QUALITY ASSURANCE -- NON-CONFORMANCE REPORT

Location: Changxing Island, Shanghai, P.R. China**Report No:** NCR-000660**Prime Contractor:** American Bridge/Fluor Enterprises, a JV**Date:** 28-Jan-2010**Submitting Contractor:** Zhenhua Port Machinery Company, Ltd (ZPMC), Changxing Island**NCR #:** ZPMC-0631**Type of problem:**

Reference Description: Missed UT indication by QC on Segment 8CE Floorbeam to Deck Stiffener**Description of Non-Conformance:**

Subject: NCR No. ZPMC-0631

WELD NUMBER: SSD18-PP70-144

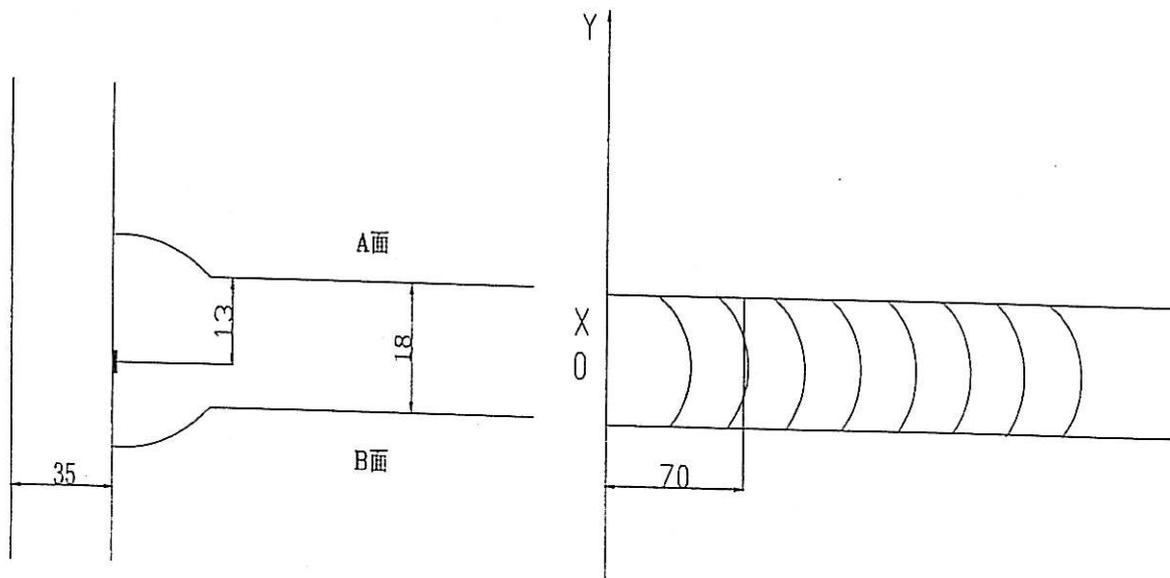
Rejected indication found by ultrasonic inspection is less than the maximum allowance aggregate length.

(UT探伤发现的缺陷总长度小于最大允许长度。) SSD18-PP70-144

1. 焊道未及时处理干净。
1. Did not clear the weld pass completely in time.

1. 从缺陷距离端面较近一侧 ($D \leq 0.65T$, D 为缺陷深度, T 为板厚) 采用碳刨或打磨的方法去除焊缝缺陷;
 2. 参照返修焊接工艺规程 (WPS) 准备正确的接头型式, 预热和焊接;
 3. 焊前对修补区域进行VT检测保证缺陷完全被清除;
 4. 将修补区域打磨到与母材或邻近焊缝平齐;
 5. 对焊缝进行UT检测, 检测范围为返修区域以及其两端各延长50mm。
-
1. Gouge or grind from nearer side from metal edge ($D \leq 0.65T$, "D" is depth of defects, "T" is thickness of metal) to remove all defects;
 2. Follow repair WPS for joint preparation, preheat, and weld deposit;
 3. Verify with VT no defects remain in the weld joint prior to welding;
 4. Grind the repaired area flush with base metal or the adjacent weld;
 5. Perform UT inspection to the weld along with 50mm on each end of the repair area;

WELD NUMBER: SSD17-PP69-136

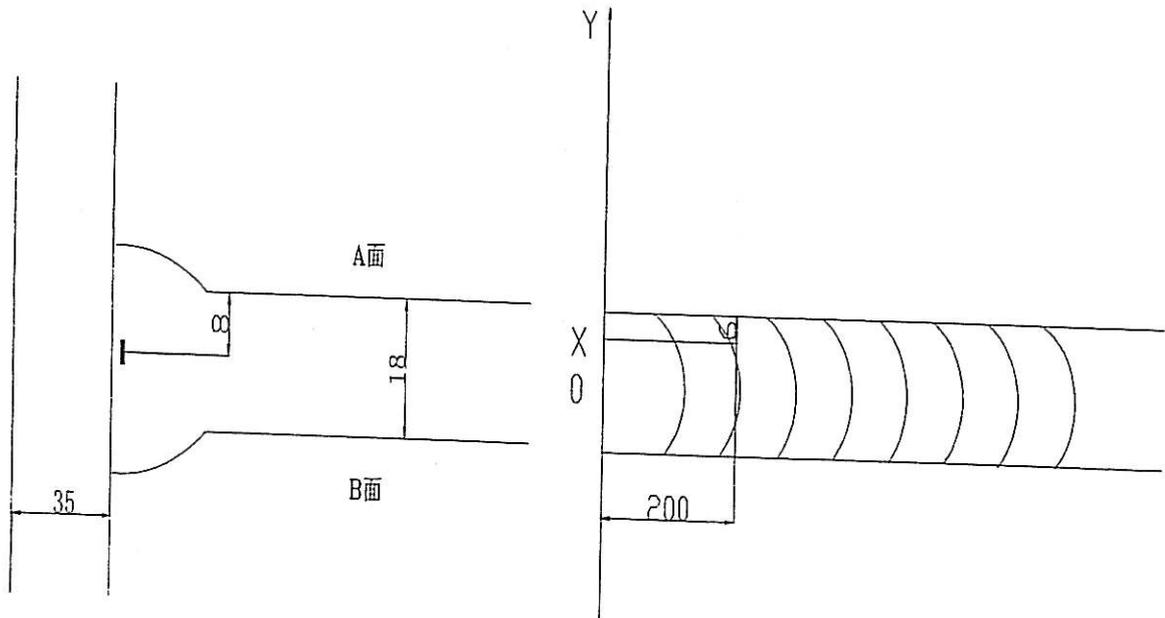
Rejected indication found by ultrasonic inspection is less than the maximum allowance aggregate length.

(UT探伤发现的缺陷总长度小于最大允许长度。) SSD17-PP69-136

1. 焊道未及时处理干净。
1. Did not clear the weld pass completely in time.

1. 从缺陷距离端面较近一侧 ($D \leq 0.65T$, D 为缺陷深度, T 为板厚) 采用碳刨或打磨的方法去除焊缝缺陷;
 2. 参照返修焊接工艺规程 (WPS) 准备正确的接头型式, 预热和焊接;
 3. 焊前对修补区域进行VT检测保证缺陷完全被清除;
 4. 将修补区域打磨到与母材或邻近焊缝平齐;
 5. 对焊缝进行UT检测, 检测范围为返修区域以及其两端各延长50mm。
-
1. Gouge or grind from nearer side from metal edge ($D \leq 0.65T$, "D" is depth of defects, "T" is thickness of metal) to remove all defects;
 2. Follow repair WPS for joint preparation, preheat, and weld deposit;
 3. Verify with VT no defects remain in the weld joint prior to welding;
 4. Grind the repaired area flush with base metal or the adjacent weld;
 5. Perform UT inspection to the weld along with 50mm on each end of the repair area;
